Engineering Bulletin

EB-0404

Product : All Eclipse Exciters and Receivers (exclude 50 Series)

Topic : DCS, CWID, Pilot Tone are available in Eclipse series Products

Figure 1

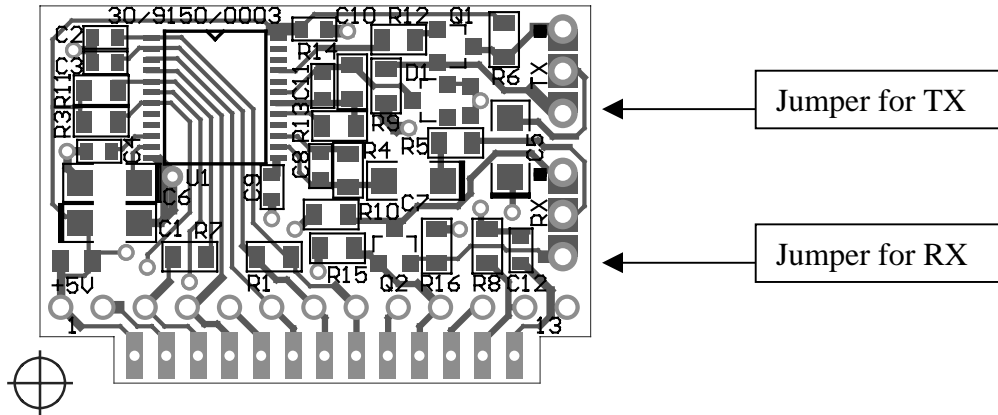
There are two jumpers on new sub-tone module for selecting the polarity of the DCS.

Connect solder pads marked with dots and the center solder pads to select the normal polarity; connect the center and bottom solder pads to reverse the polarity.

Figure 2 RX PCB Top layer

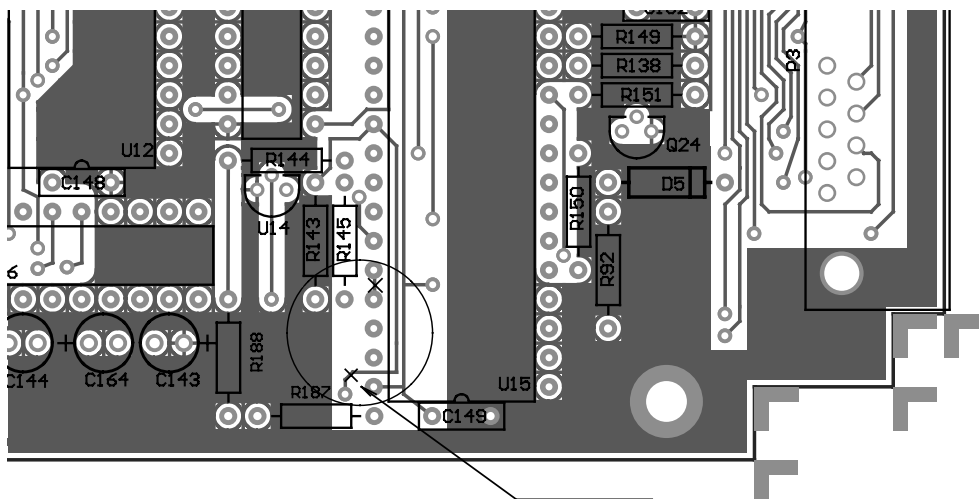
1. Change Crystal Y2 from 4MHz to 4.032MHz
2. Cut the tracks and add connections as shown in Figure 2. Figure 3. Figure 4

Cut two tracks marked with crosses

Figure 5 Tx PCB bottom layer

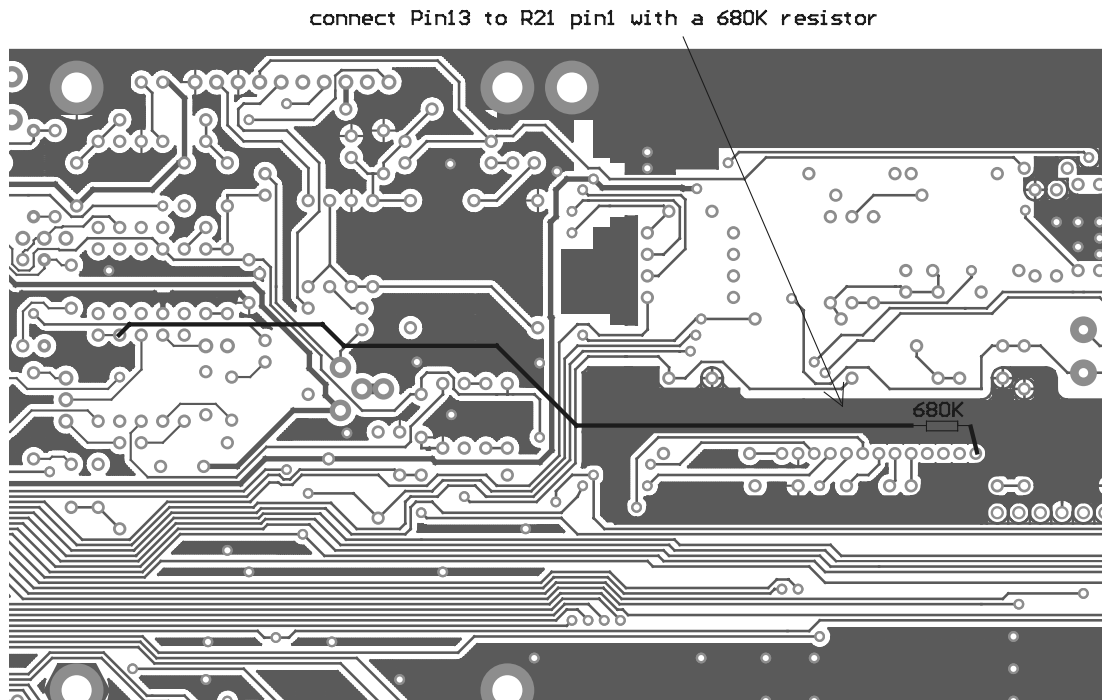
1. Change Crystal Y2 from 4MHz to 4.032MHz
2. Change R44 from 6K8 to 15K
3. Add connections as shown in Figure 5
